PRODUCT/PROCESS CHANGE NOTICE (PCN)

PCN #: **SR-0505-02** DATE: **8/3/2005**

Product Affected: FPBGA 165 (BQ165) Package

Example of FPBGA 165 Package Top Mark

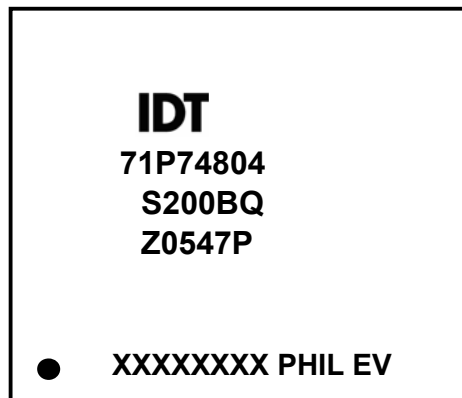
Encrypted assembly date code suffix on the assembly lot number

XXXXXXXX = Assembly Lot Number
PHIL = Country of Origin
EV = Assembly Date Code

EV

└─┬─> ww 45 - 46
└─┬─> 2005
